Work Order ID 133608

Item Name: Crosstube Turning Detail

DRAWING NO. D407-667-145	TITLE CROSSTUBE ASS'Y (407 HIGH FWD)	REV. C	DART AEROSPACE LTD ENGINEERING ORDER		D.E.O. NO. D407-667-145-C-1	SHEET NO. SHEET 1 OF 1	SCALE NTS
DRAWN 97	CHECKED ASS	MFG. APPR. 128	APPROVED WD		DE APPR. H		
DATE 11.07.15	DATE 11.07.22	DATE 11.07.22	DATE 11/07/22		DATE 11.07.21

DRAWING NO. D407-667-145	TITLE CROSSTUBE ASS'Y (407 HIGH FWD)	REV. C	DART AEROSPACE LTD ENGINEERING ORDER		D.E.O. NO. D407-667-145-C-2	SHEET NO. SHEET 1 OF 1	SCALE NTS
DRAWN AJS	CHECKED	MFG. APPR.	APPROVED		DE APPR.		
DATE 12.08.02	DATE 12.08.02	DATE 12.08.02	DATE 12.08.02		DATE 12.08.02

DETAIL P
BONDING STRAP INSTALLATION 2 PL

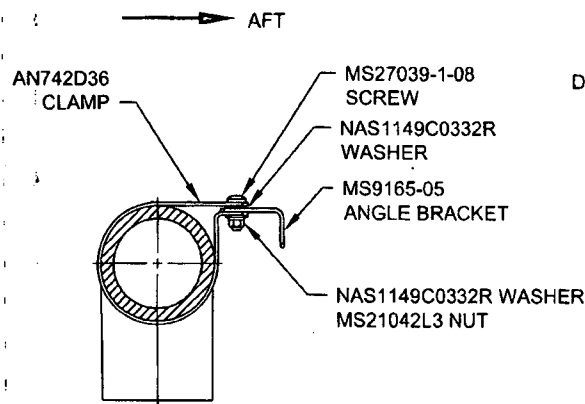
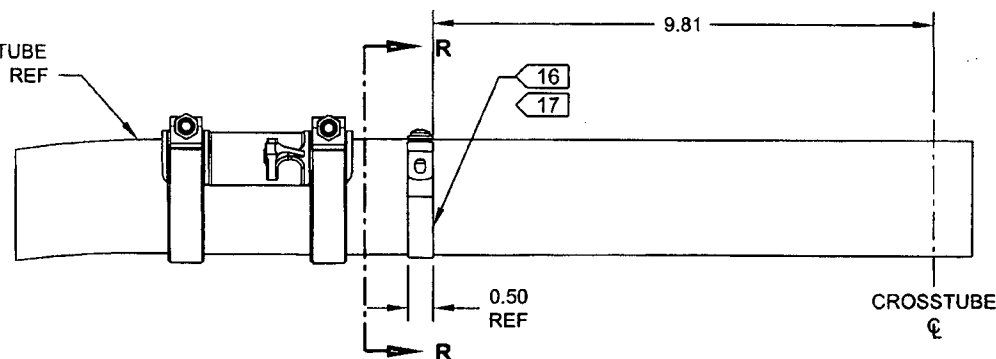
ADD ELECTRICAL GROUNDING STRAP

ITEM	QTY -145	PART NUMBER	DESCRIPTION
1	X	D407-667-145	CROSSTUBE ASSEMBLY (407 HIGH FWD)
10	2	AN742D36	CLAMP
11	2	MS9165-05	ANGLE BRACKET
12	2	MS21042L3	NUT (OR MS21042-3)
13	2	MS27039-1-08	SCREW
14	4	NAS1149C0332R	WASHER (OR AN960C10L)

- 16) MASK AREA UNDER CLAMP PRIOR TO PAINTING
- 17) SEAL EDGES WHERE AN742D36 CLAMP MEETS WITH THE CROSSTUBE USING SIKAFLEX-241/-291 OR MIL-S-8802 CLASS B2 OR PROSEAL 890 SEALANT
- 18) PERFORM RESISTANCE CHECK TO ENSURE MAX RESISTANCE IS 10 MILLIOHMS
